<b>Office Action Summary</b>	<b>Application No.</b> 10/706,726	<b>Applicant(s)</b> STREUER, PETER
	<b>Examiner</b> Ben Lewis	<b>Art Unit</b> 1795

**DETAILED ACTION**

2. Claims 1, 2 and 10 rejected under 35 U.S.C. 103(a) as being unpatentable over Krabatsch et al. European Patent No. (DE 33 30 823 A1)

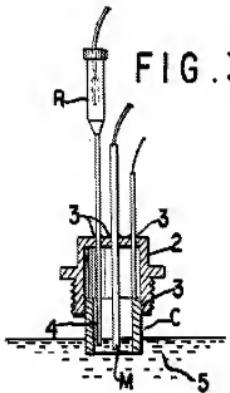
With respect to claims 4 and 12, With respect to claims 1 and 2, Krabatsch et al. discloses a plug for an accumulator "battery". The plug has degassing openings **9** and **19** and **18** (See Figure).

Krabatsch et al. teach an upper part **21** with opening **18** to the outside and a lower part **7** (See Figure). Opening **18** is also connected to the splash basket **7** (See Figure).

Krabatsch et al. teaches an acid cage **7** "splash basket" having an inner diameter that increases from the free end to the upper end of the acid cage and slots

continuing as far as the free end of the splash basket (See Figure) (See page 2 line 1-10).

With respect to the shape of the slots, Krabatsch et al. do not specifically teach wherein each of the slots has a width that broadens with increasing distance from the free end of the splash basket. Unless applicant shows criticality for the claimed features, changes in size and shape is obvious absent a showing of unexpected results.

It is noted that applicant's slot widths and basket shape appear to be similar to, if not identical to that shown in the Figure in DE 3330823.

With respect to slots including a free end extending toward the free end of the splash basket, Krabatsch et al. teach that feature **10** of the plug is an opening. Since, there is no showing of unexpected results or showing of criticality of the end of Applicant's slots being free as claimed by the Applicant as opposed to the slots of Krabatsch et al. having lower edge support **24** at the end of the slots of Krabatsch et al., the plug of Applicant is obvious variant of the plug of Krabatsch et al. Examiner also notes that without the oring 24 of Krabatsch et al. being present would save material costs in the plug of Krabatsch et al.
